**CITY OF AUSTIN
Board of Adjustment
Decision Sheet
F-1**

CASE NUMBER: C15-2021-0056

ADDRESS: 3006 GLENVIEW AVE

VARIANCE REQUESTED: The applicant is requesting a variance(s) from the Land Development Code, Section 25-2-515 (*Rear Yard of a Through Lot*) from setback requirements to decrease the minimum rear yard setback from 25 feet (required) to 5 feet (requested) in order to erect a detached garage/office in an “SF-3-NP”, Single-Family Residence-Neighborhood Plan zoning district. (Windsor Road Neighborhood Plan)

EXTR. ELV-1
HAMILTON
CENTRAL LIVING

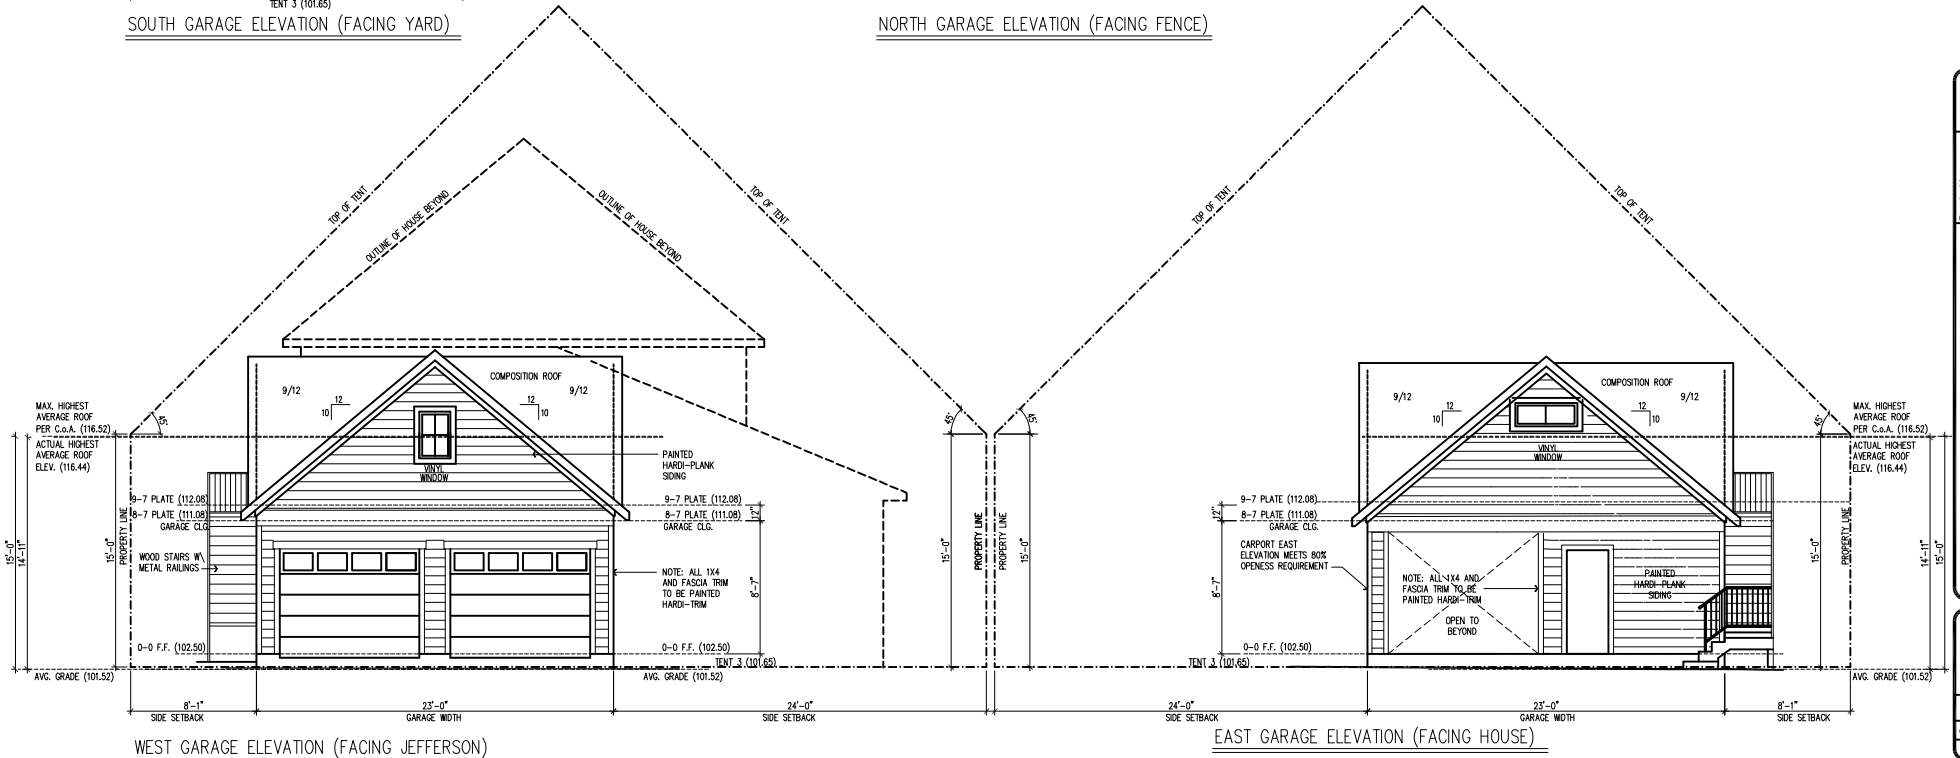
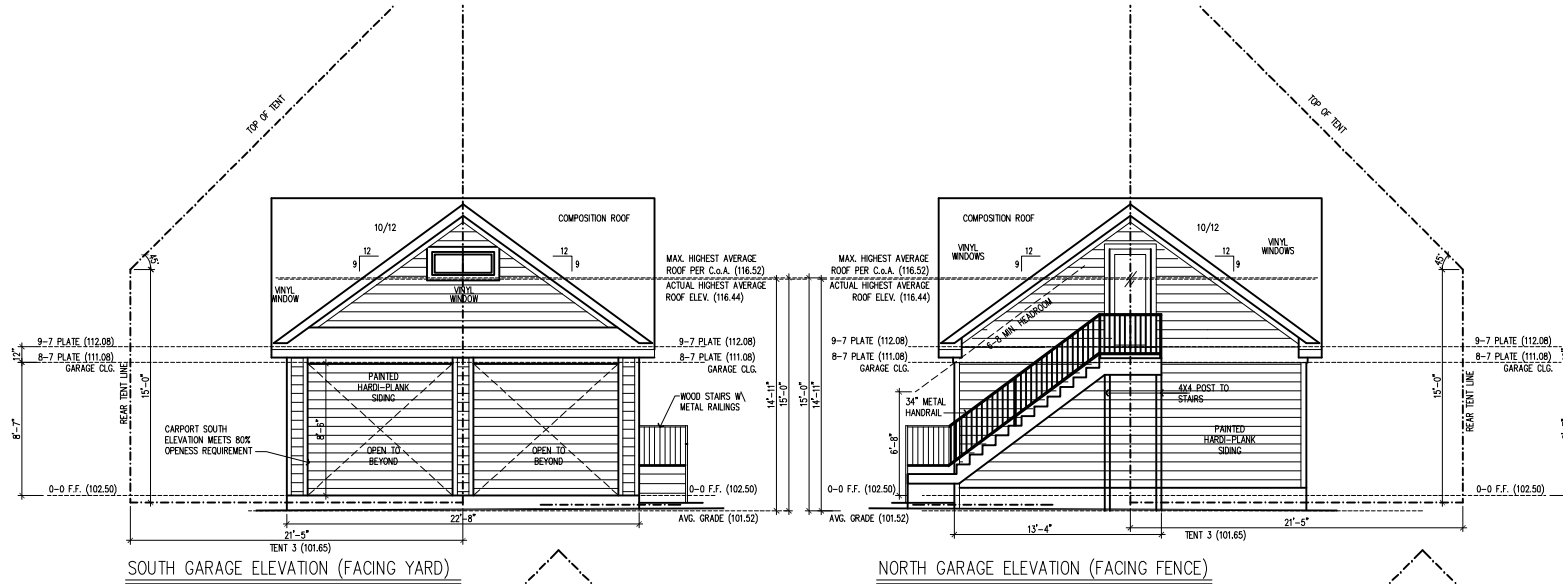
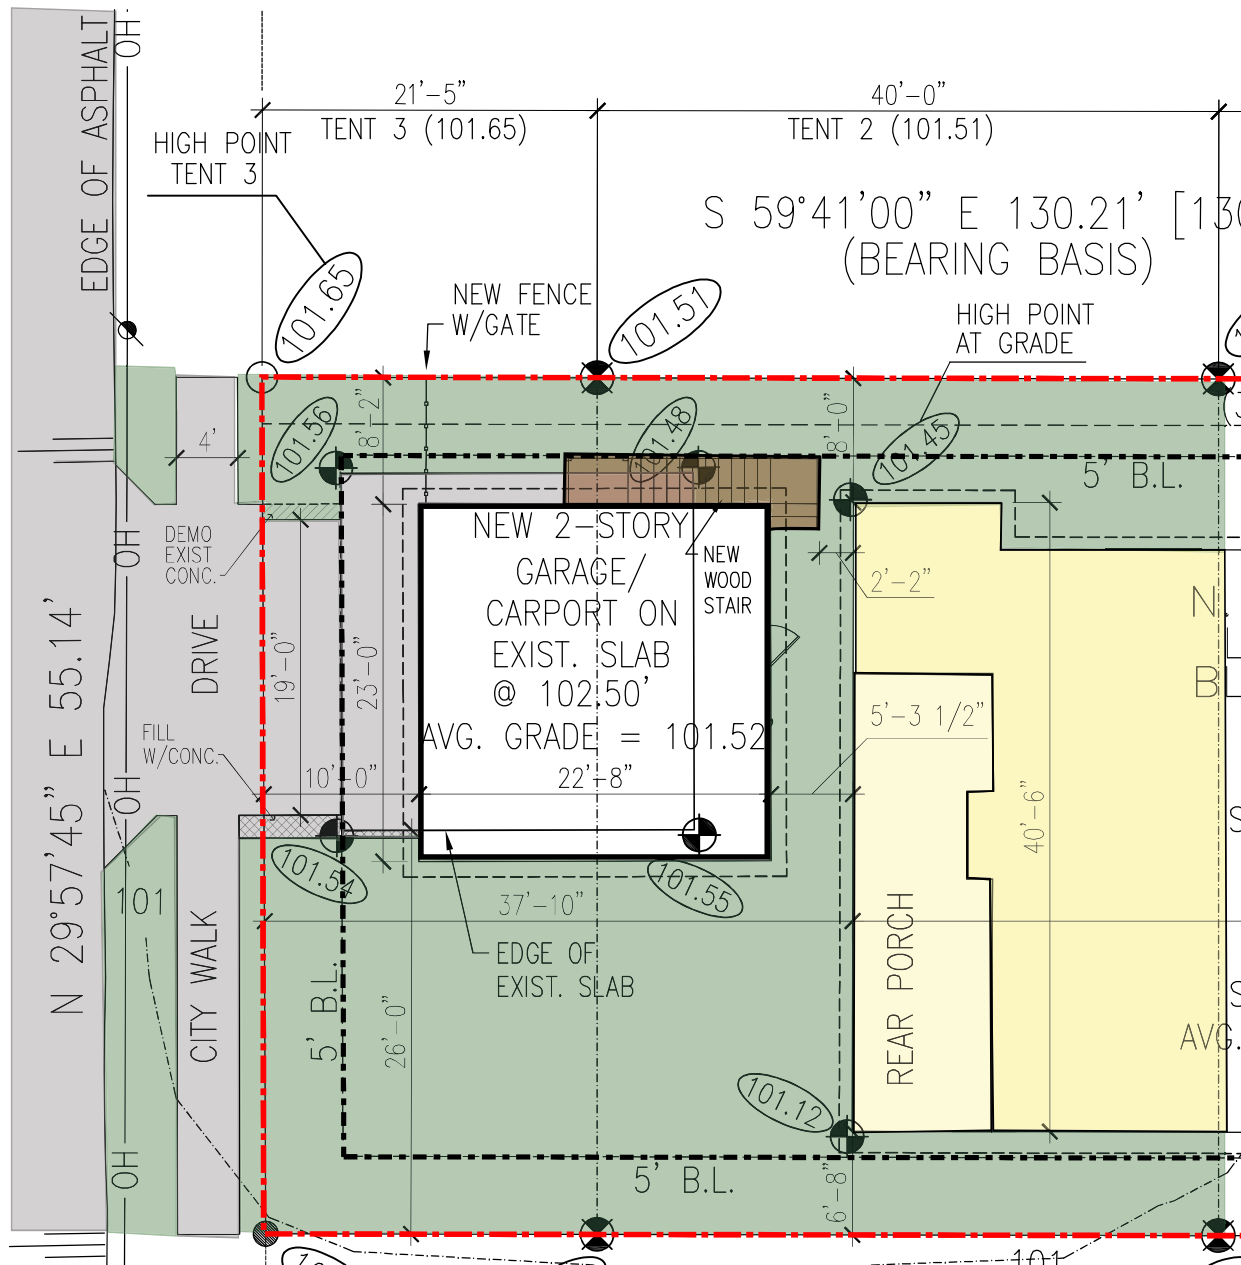
The Board of the Bryker Woods Neighborhood Association agrees with the revised variance request for the reduction of the rear yard setback from 25 to 10 ft which is in keeping with the precedent set by the Board of Adjustment in 2014, and with the additional variance request that the garage/carport/loft be moved 5 ft closer to the Hamilton's house.

Elaine, our revised application is attached and shows an additional variance request to move the building five feet closer to our primary residence. As you can see below, the neighborhood is in support of this course, hopefully the BOA will also.

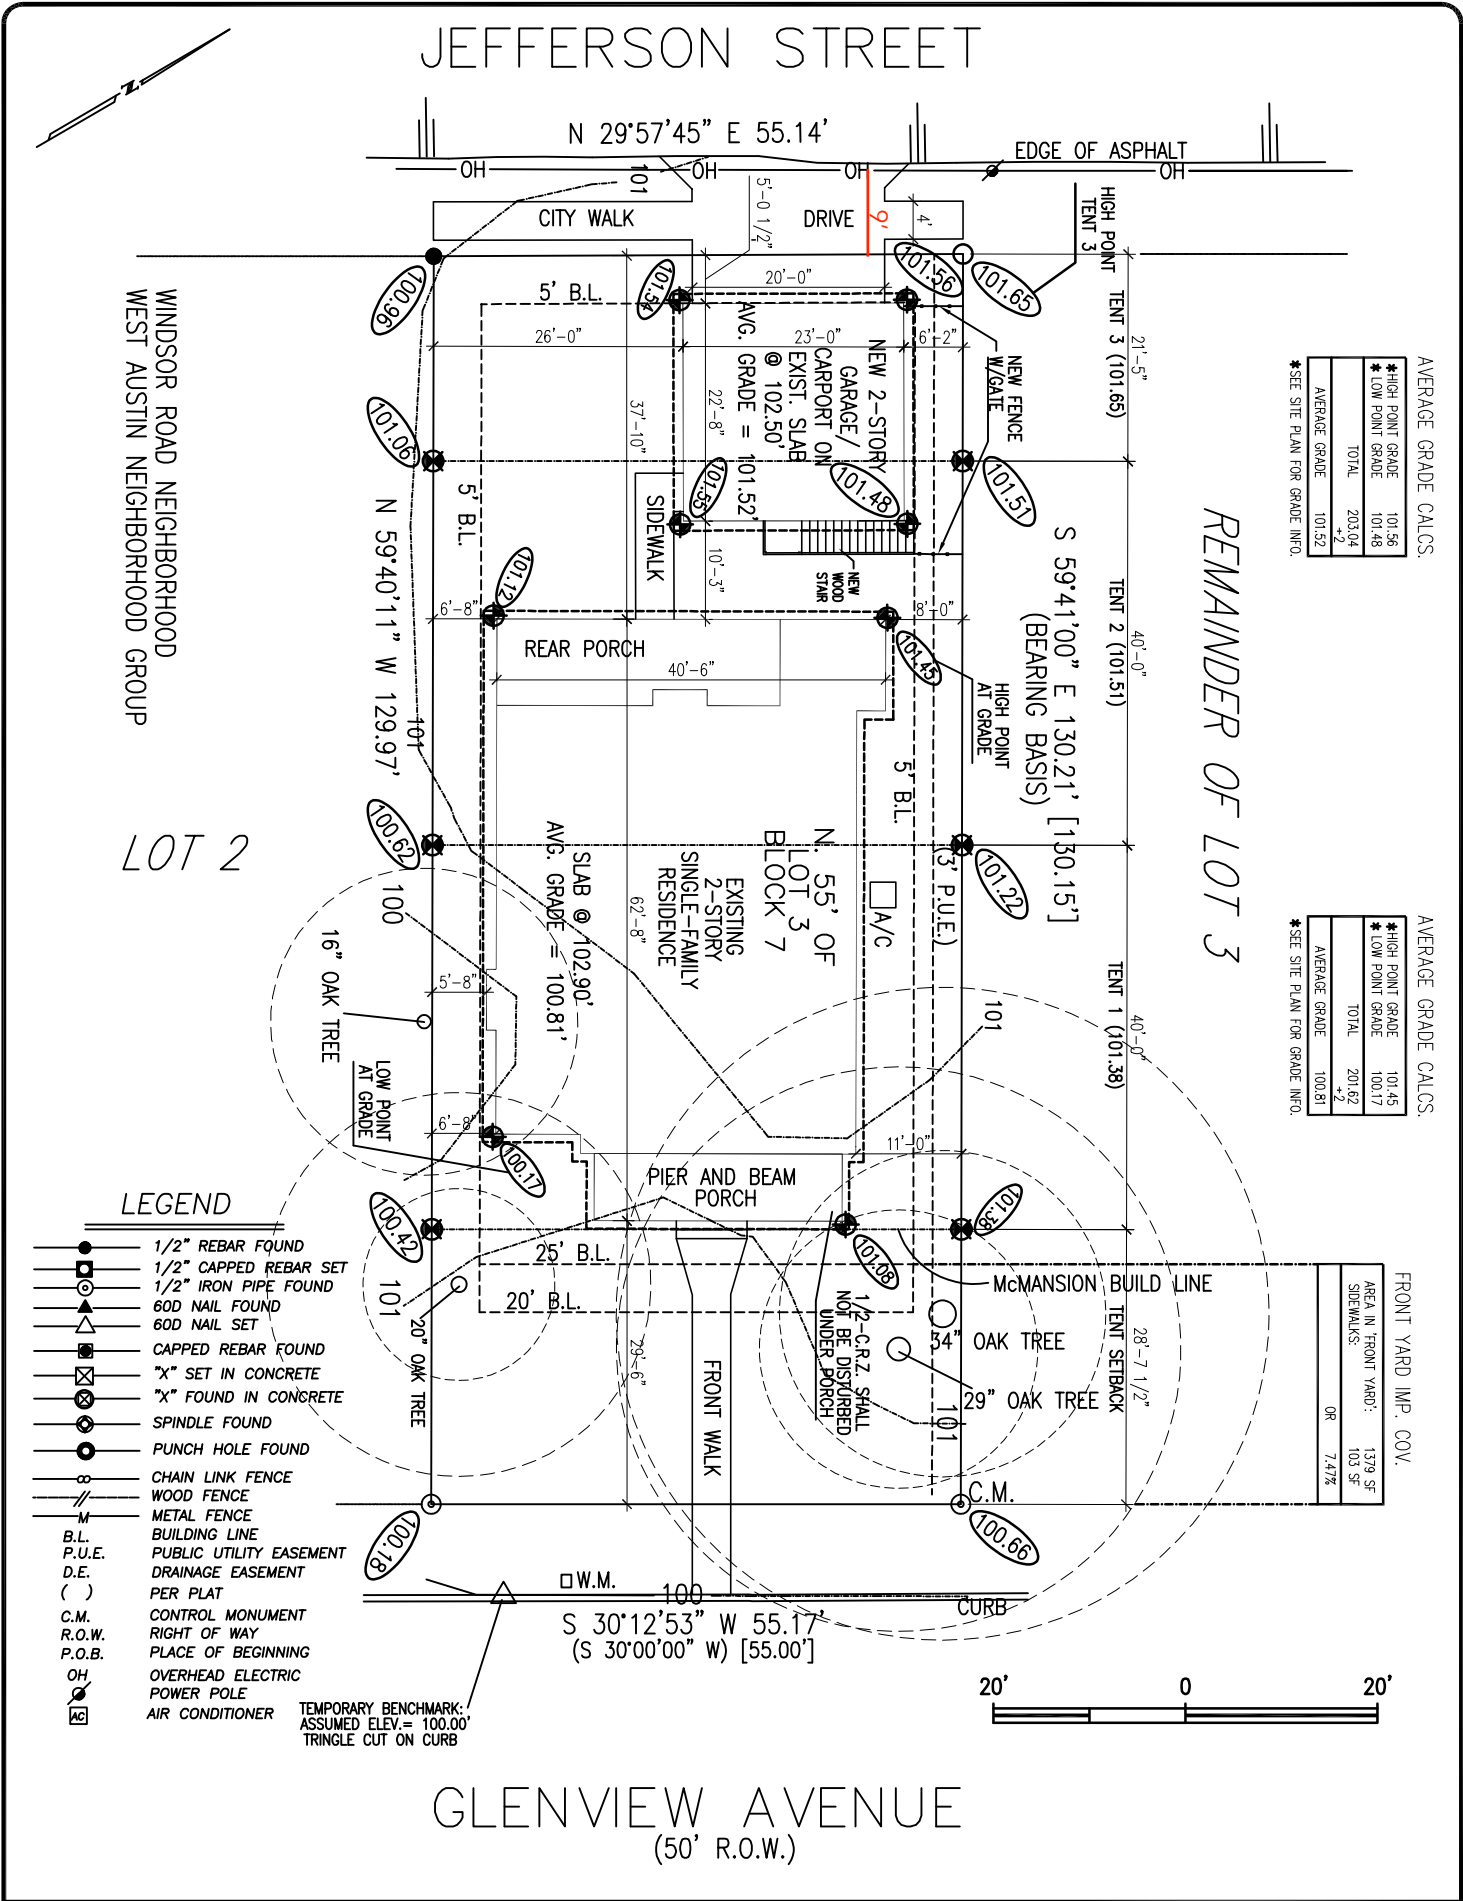
Distance from the Center OH Line to the build line is 9'. Distance from BL to the structure is 5'0.5". Utility Pole has a cross beam 8' wide making the closest line approximately 5' from the BL. Therefore, distance from structure to the closest OH line is approximately 9.5'.

Austin Energy Design Criteria 1.10.0 - Clearance & Safety Requirements:

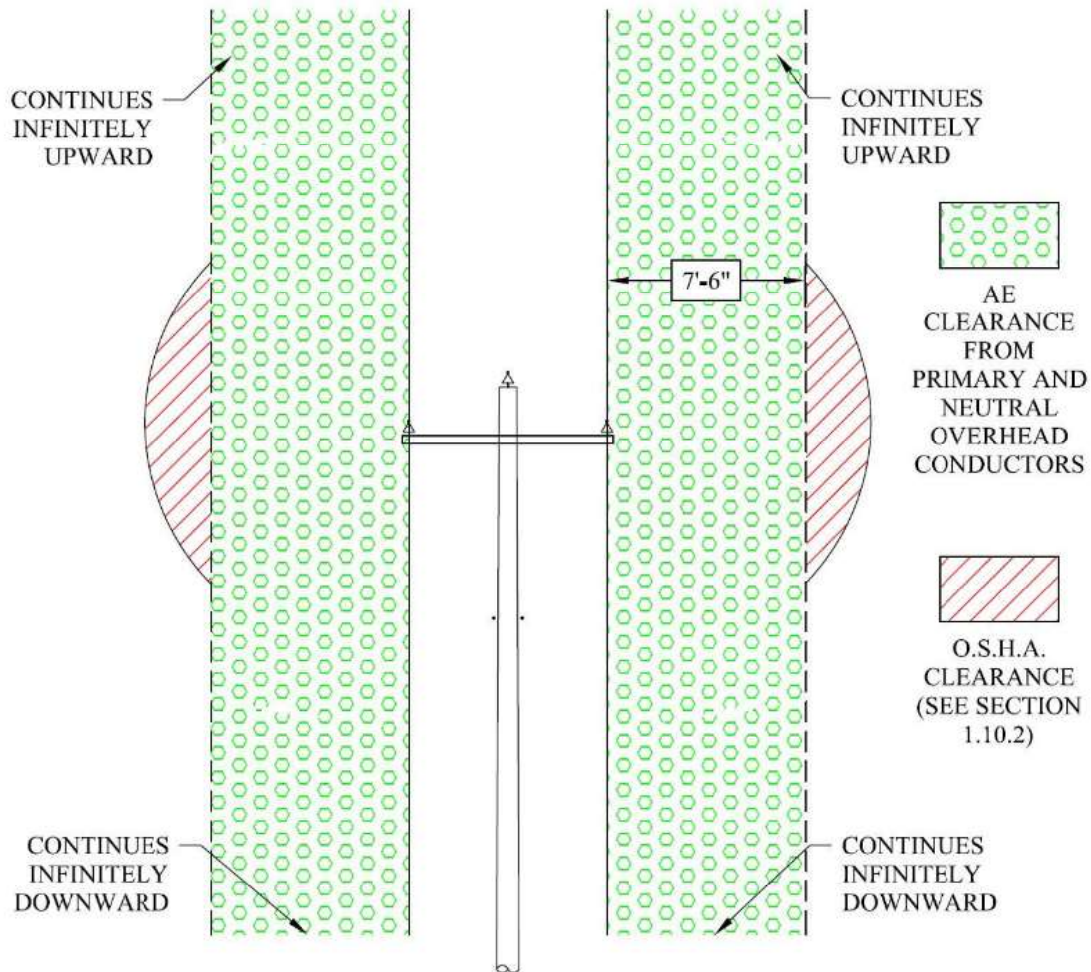
Austin Energy (AE) has reviewed your application for the above referenced property, requesting that the Board of Adjustment consider a variance(s) from Land Development Code Section 25-2-515 (Rear Yard Through Lot) in order to reduce the required rear setback from 25' to 5'. Austin Energy **opposes** approving this request until further detail regarding clearances can be provided.

While the request is similar to others approved in the area, for complete assurance, Austin Energy requests that the owner/applicant provide elevations of the proposed new structure, showing the building is able to meet the minimum horizontal clearance of 7 feet 5 inches from the outmost conductor, as required by Austin Energy's Design Criteria Section 1.10.0 (clearance & safety requirements). Below is a link to Austin Energy's Design Criteria, as well as a diagram depicting the horizontal and OSHA clearances required.
